SUBJECT: ISSUANCE OF AMENDMENT NO. 113 TO FACILITY OPERATING LICENSE
NO. DPR-51 - ARKANSAS NUCLEAR ONE, UNIT NO. 1 (TAC NO. 69056)

AMENDMENT TO FACILITY OPERATING LICENSE

Amendment No. 113
License No. DPR-51

SAFETY EVALUATION BY THE OFFICE OF NUCLEAR REACTOR REGULATION

Rod Position Setpoints for 2-Pump Operation
 From 0 to 27+10/-0 EFPD -- ANO-1 Cycle 9
 Figure 3.5.2-3A

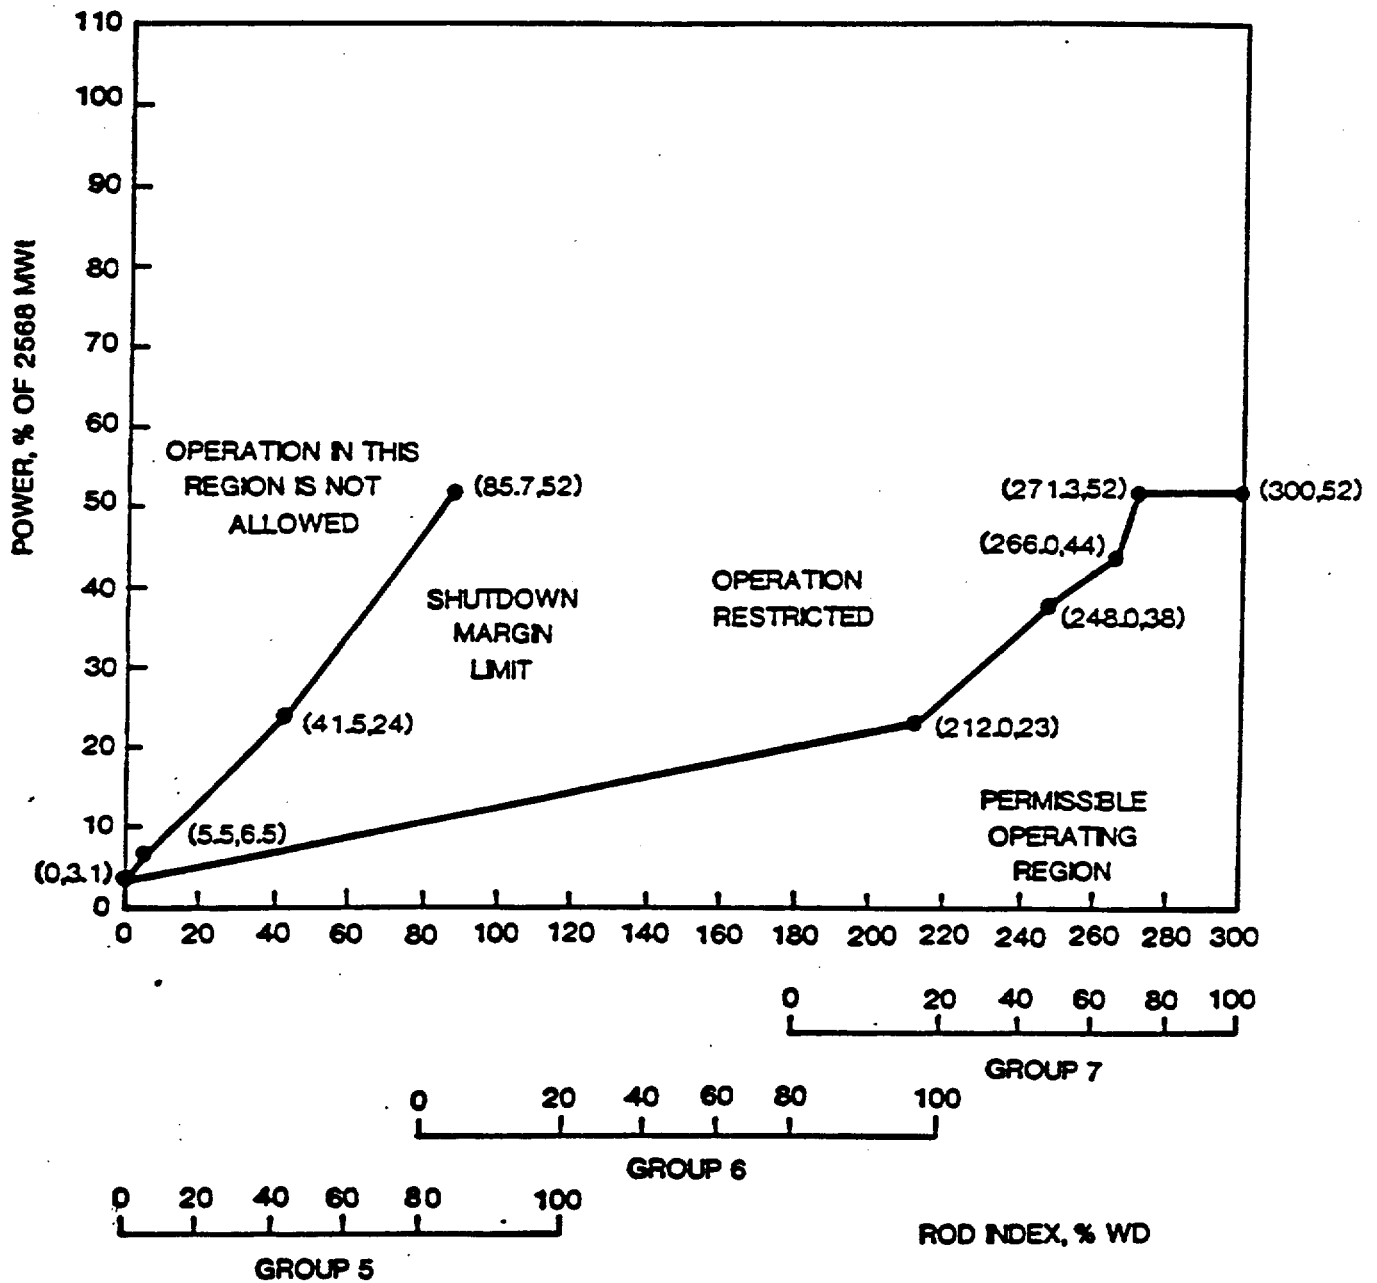
Section 3.5.2.4, 3.5.2.5.3, 3.5.2.5.4
Figures 3.5.2-1, 3.5.2-2 and 3.5.2-3, 3.5.2-4

These sections are modified to reflect new quadrant power tilt limits, changes to control rod insertion limits, operational limits on the gray axial power shaping rods (APSRs), and new operational power imbalance limit.
